Point Beach Nuclear Plant, Units 1 and 2  
Dockets 50-266 and 50-301  
Renewed License Nos. DPR-24 and DPR-27

Response (90 Day) to Request for Additional Information  
License Amendment Request Associated with NFPA 805

#### RESPONSE (90 DAY) TO REQUEST FOR ADDITIONAL INFORMATION LICENSE AMENDMENT REQUEST ASSOCIATED WITH NFPA 805

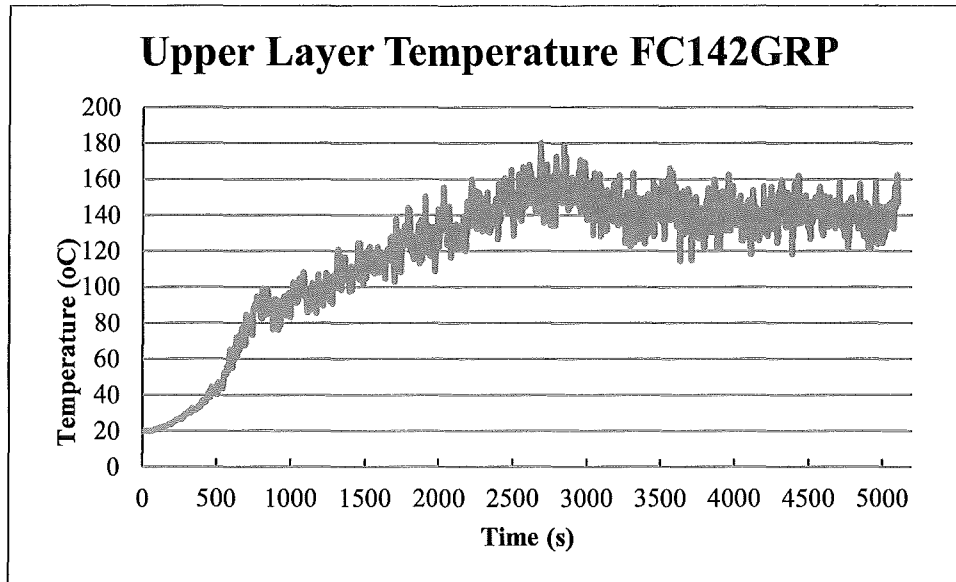
- f) *Specifically regarding the use of the algebraic models:*
  - i. *Explain how horizontal vents, and vents at or near the ceiling of the compartment were treated in the Method of McCaffrey, Quintiere, And Harkleroad (MQH) calculations; and*

**Fire Compartment 142GRP (CCW Pump Room)** has two large open horizontal vents in the ceiling in the form of an open stairwell (13 ft. by 15 ft.) and an open hatchway (12 ft. x 15 ft.), with a total open horizontal vent area of 375 ft<sup>2</sup>. The horizontal vent area was added to the vertical open vent area seven open doorways and miscellaneous open wall penetrations, totaling 345 ft<sup>2</sup>) and modeled as a single vertical vent measuring 30 ft. by 24 ft. (720 ft<sup>2</sup>). The top of the vent was modeled at ceiling height due to the location of the horizontal vents in the ceiling and the height of the open doorways and penetrations.

In order to demonstrate that this approach is acceptable, FC 142GRP was modeled in FDS using the same dimensions modeled in the DFMWB. Each vent, both vertical and horizontal, was modeled individually instead of combined and the most conservative HRR profile was selected from the DFMWB, including any secondary combustibles. The FDS results for the most conservative HRR profile indicate that the upper gas layer temperature only reaches 180°C, which does not result in the formation of a damaging HGL (205°C). This is consistent with the original DFMWB results and further analysis is not required. FDS was used within the limits of applicability and the analysis was performed within the validated range of NUREG-1824. Refer to the table at the end of this response for evaluation of the relevant normalized parameters. The FDS results are provided in the figure below.

**Figure 1: Zone of influence for each Circulating Water Pump**

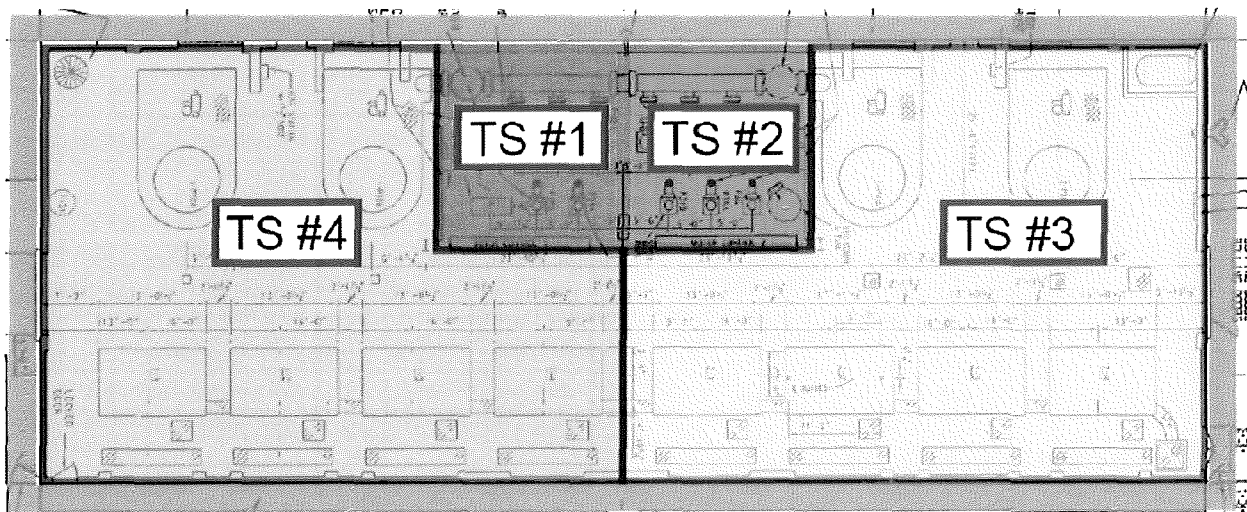
- ii. *Describe in detail how the time to sprinkler activation and the time to heat and smoke detector actuation was calculated.*
- g) *Specifically regarding the CFAST analysis in compartment 552GRP, discuss whether the potential damage was assessed for targets in the lower gas layer (LGL) due to the combined radiant heat flux from the HGL, heated surfaces and the flame. Describe the results of this assessment, and the damage thresholds that were used in this assessment. If a damage assessment based on radiative heat flux (or combined radiative and convective thermal exposure) was not performed, provide technical justification for the assumption that the LGL temperature damage threshold is bounding.*

The CFAST analysis justifies the use of target failure sets limited to those targets within the line of sight of each pump. Although the lower gas layer does not exceed 205°C, FPRA target failures are assumed and accounted for due to direct flame impingement, damaging plume temperatures, radiant heating, and combined thermal exposure impacts. Attachment 1 of Detailed Fire Modeling Report R2168-001-552GRP, details the zone of influence for each pump as well as the damaged FPRA target sets. Therefore, potential damage for targets in the lower gas layer (LGL) due to the combined radiant heat flux from the HGL, heated surfaces, and the flame are addressed by the zone of influence failures in Detailed Fire Modeling Report R2168-001-552GRP.

The zone of influence for each pump is provided in Figure 1, with all targets within TS#4 failing due to a large oil fire at pump 1P-30A or 1P-30B and all targets within TS#3 failing due to a large oil fire at pump 2P-30A or 2P-30B. Target failure was conservatively assumed to fail at time zero.

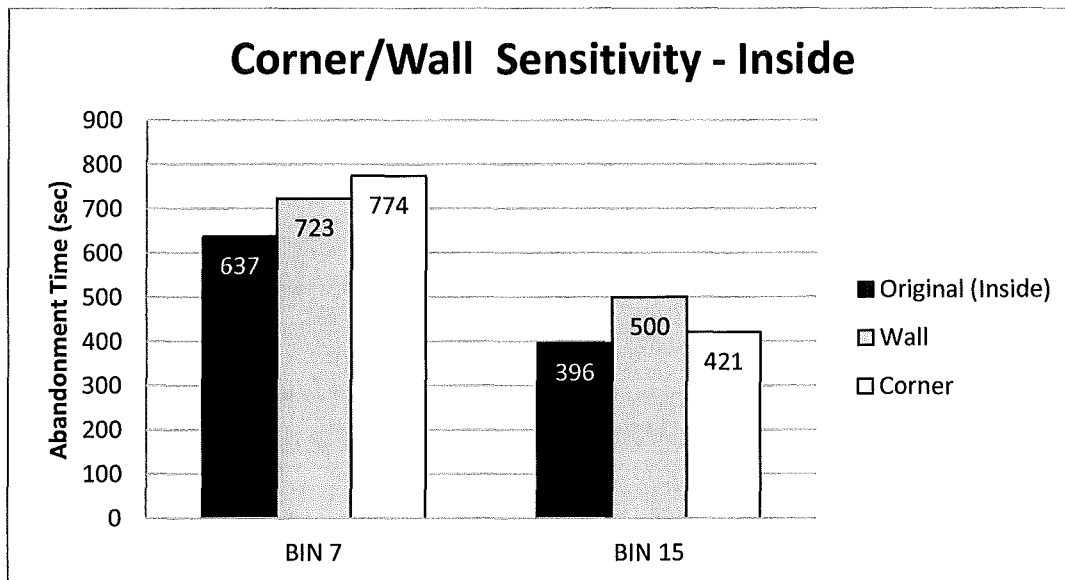
- ii. *FDS simulations were performed with cabinet and transient fires located at four different locations. Describe the technical basis that was used for choosing these locations;*
- iii. *Provide technical justification for assuming that transient fires in the MCR reach peak HRR in 8 min;*

- ii. Two transient and two electrical cabinet scenario locations were postulated for the Main Control Room (MCR) abandonment analysis. The locations of the fires were selected to bound a fire at any location within the room. Each electrical cabinet fire scenario location was conservatively selected such that the fire would spread to two additional cabinets, based on the methodology provided in NUREG/CR-6850, Appendix S, and thereby bound the heat release rate (HRR) of any electrical cabinet scenario. Locations for the transient fires were selected both inside and outside of the horseshoe at locations in close proximity to the main control boards and operators. Devices that measure habitability conditions were located near the fire locations to provide data to conservatively calculate when control room abandonment would be necessary.

The primary goal of the analysis was to determine the effect of the hot gas layer on habitability conditions within the MCR and, therefore, varying the location of the fires modeled in FDS would lead to similar, or potentially less severe, abandonment times. For example, transient scenarios placed farther away from the control boards would have delayed effects on the operators, and single electrical cabinet fires generate less heat and smoke than multi-cabinet fires with much higher heat release rates.

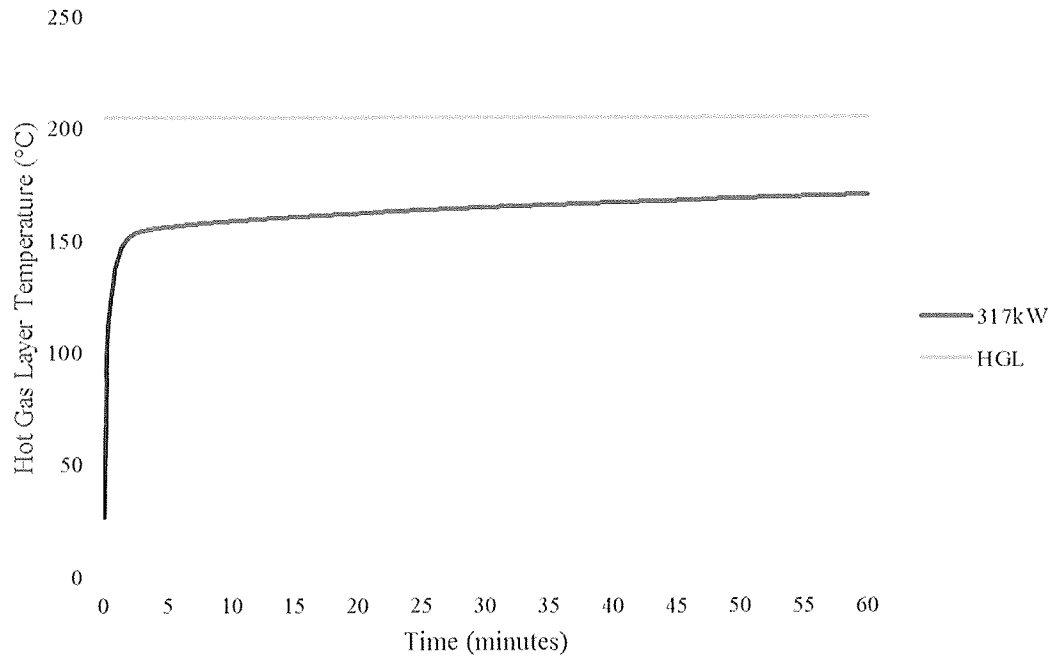
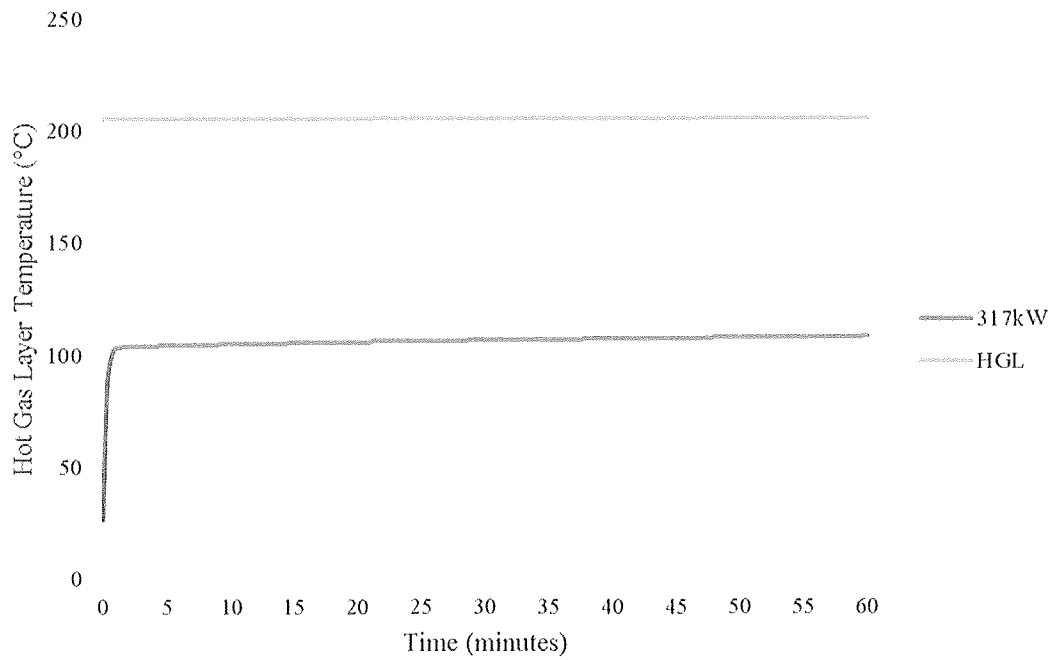
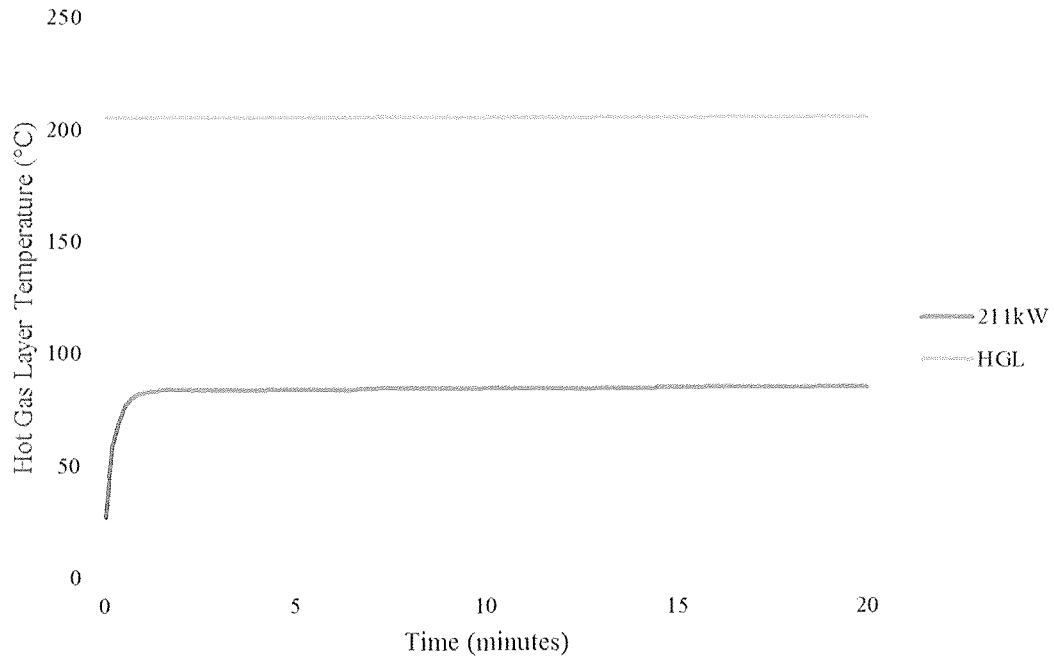
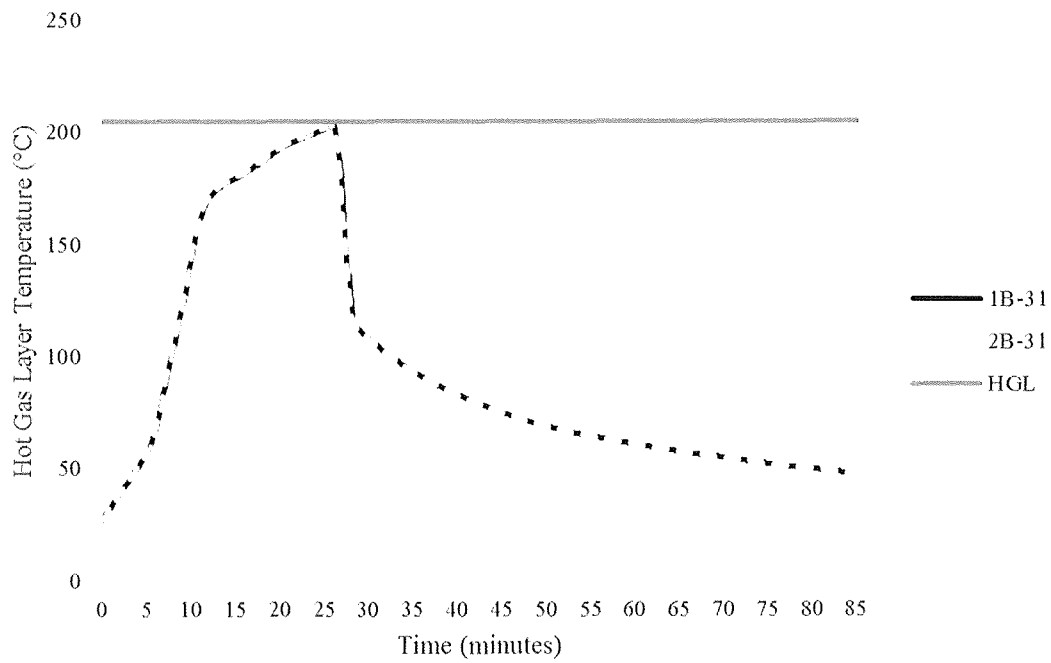
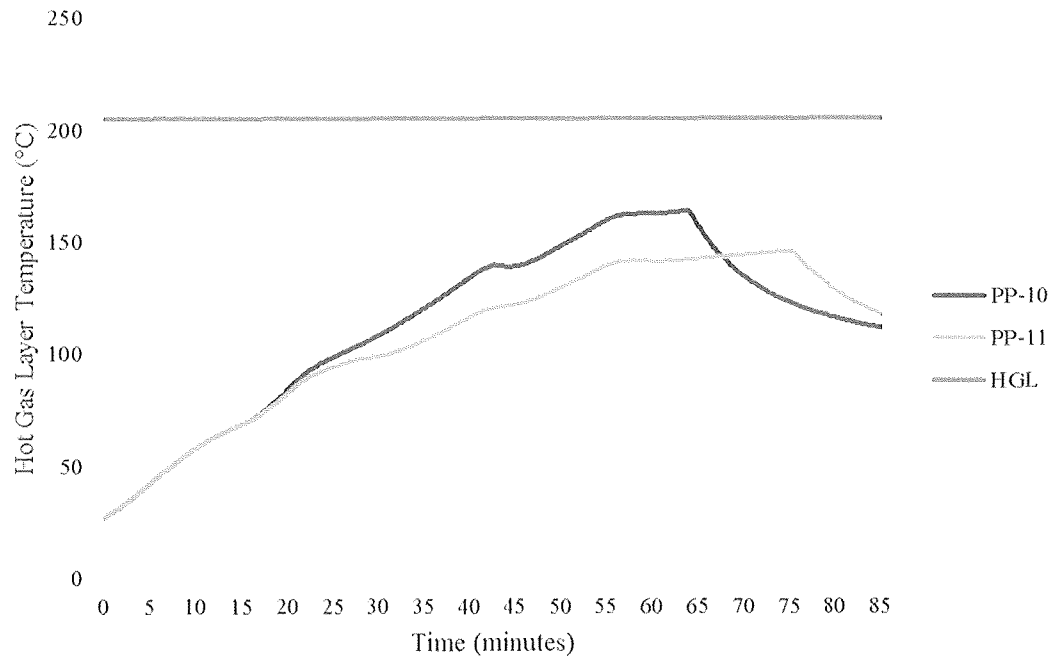
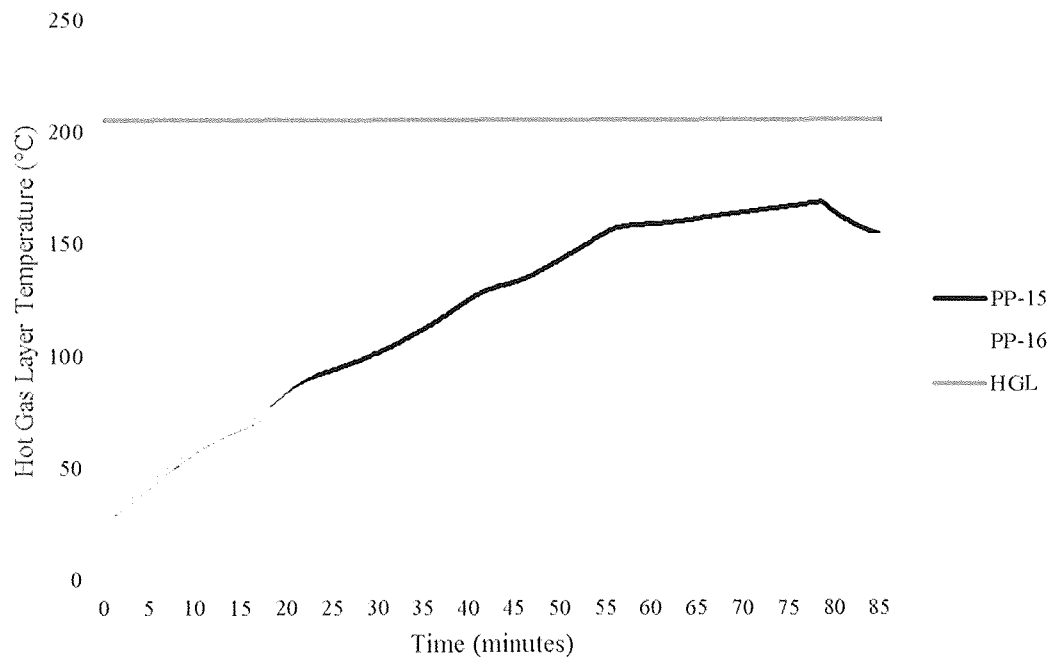
- a) The NRC staff notes that algebraic models cannot be used outside the range of conditions covered by the experiments on which the model is based. NUREG-1805, includes a section on assumptions and limitations that provides guidance to the user in terms of proper and improper use for each FDT. There is general discussion of the limitations of use for the algebraic equations that has been utilized for hand calculations. It is not clear, however, how these limitations were applied on the individual fire areas or for the MCA. Provide a description of how the limit of applicability was determined for each fire area.*

The CFAST sensitivity analyses results are summarized as follows:
